Product Change Notification

Date Issued :	November 07, 2024	PCN Number :	515275
Reason for Change :	Change to Product		
Description of Change :	This notification is to inform you about changes that are being made to the part(s) as identified in the list. This change will affect the Fit, Form, Function, or appearance of the parts. Or it may result in a change to the specification or raw material.		
Assessment of Change :	First Article Inspection		
Planned Implementation Date :	May 07, 2025		
Customer Sample Availability Date:	May 03, 2024		
Last date to request Samples by Customer :	December 20, 2024		
Please note if Samples are not requested as per Customer Samples Request date, it may take additional 4-6 weeks to arrange Samples.			
Traceability Code Markings / Date :	No special marking on the product or packaging

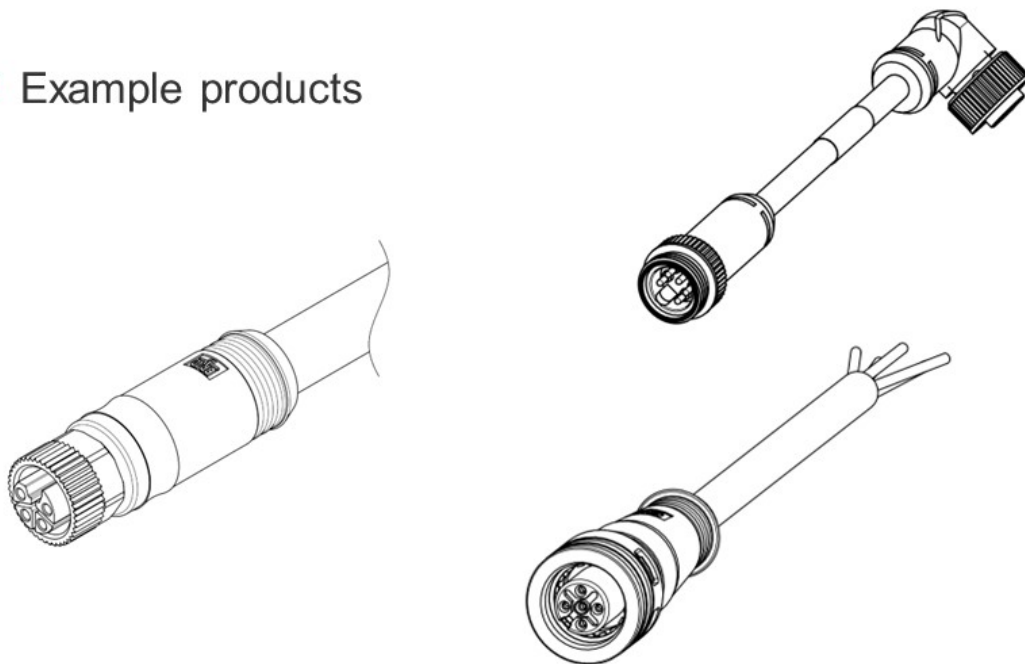
- In an effort to better align our component inventory strategy for the global market what will ensure continuity of supply chain, we change black colorant for overmold material. New colorant was defined and qualified by Molex engineering team.

- Product Impact
 - No impact to fit, form or function
